Wizard SMR (Self-Monitored Ready) Wiring Configuration Change with the Stanley Duraglide Sliding Door

MAY 08, 2002

WIZARD WITH NEW STYLE STANLEY INTERFACE BOARD

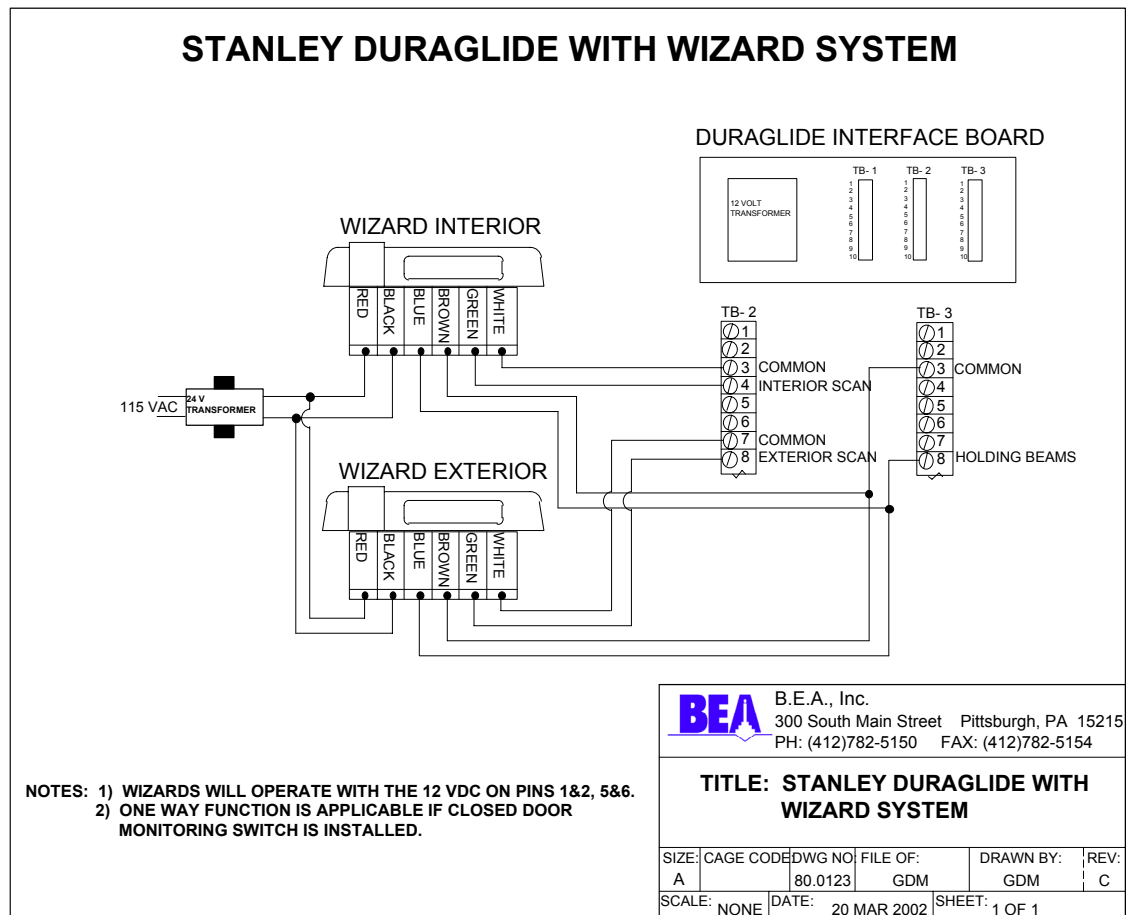
The purpose of the change is to accommodate for the differences in the Standard Rocker Switch package and the Rotary Switch package. The standard wiring provided with the Rotary Switch Package requires that the Wizard sensor system be wired as shown.

When using the Stanley Rotary Switch on a Duraglide slider package with a newer style Stanley interface board, observe the following:

- The brown wire from the Wizard must be connected to terminal #3 (Common) on TB-3 of the interface.
